# SERVICE BULLETIN SUMMARY

MODEL BD-700-1A10 (BD-700)

**MODIFICATION – VOICE RECORDER SYSTEM – INSTALLATION OF RECORDER INDEPENDENT POWER SUPPLY (RIPS) FOR COCKPIT VOICE RECORDER (CVR)**

**700-23-033**  
Page 8 of 8

**KDG991-3101** – Kit – Communications CVR - Addition of RIPS Tray  
(Sheet 1 of 1, Rev. - -)

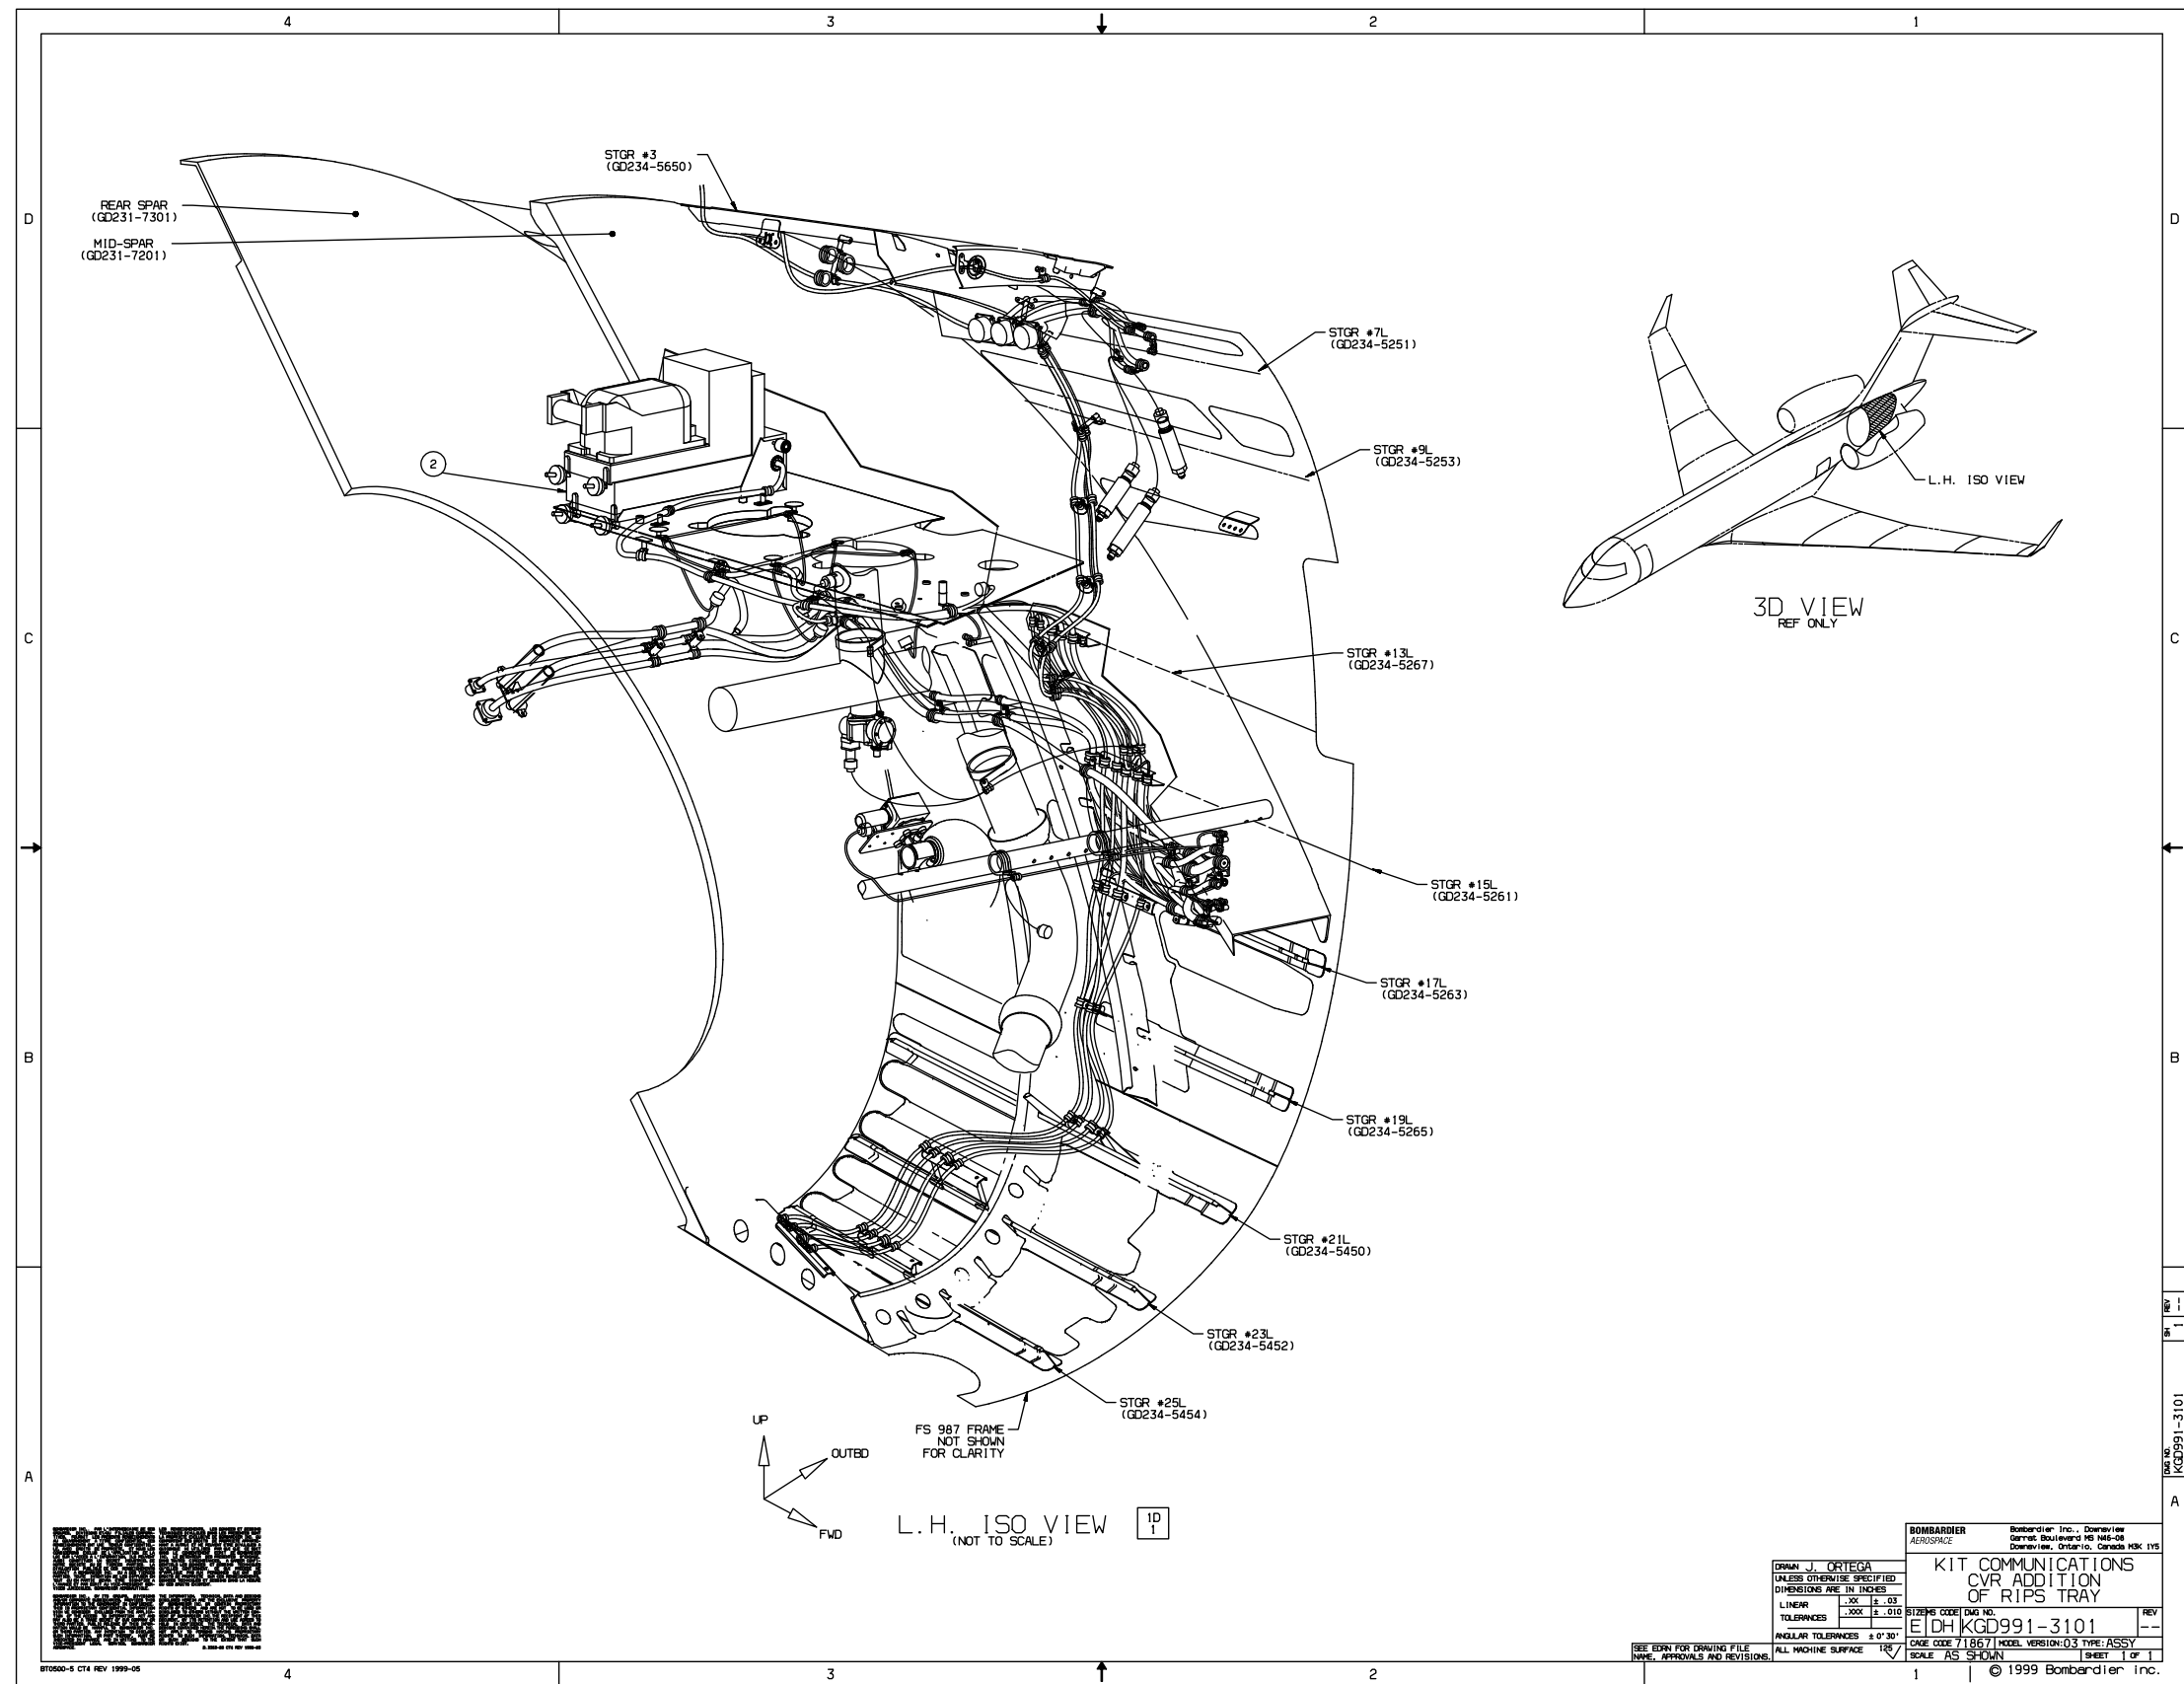
This Service Bulletin introduces an independent power source for the CVR that meets the FAA requirements. Incorporation of this Service Bulletin will ensure that the operator has met the new FAA requirement.

- (1) Remove the protective covers from the electrical connectors on the CVR and the RIPS.
- (2) Install the RIPS on the CVR mounting tray and ensure the electrical connectors are properly engaged.
- (3) Install the CVR on the RIPS. Refer to Kit Drawing KGD991-3101.
- (4) Set, tighten and engage the captive front clamps on the CVR.
- (5) Do the bonding test between the CVR and aircraft structure. Refer to SPM TASK 51-80-00-760-801.
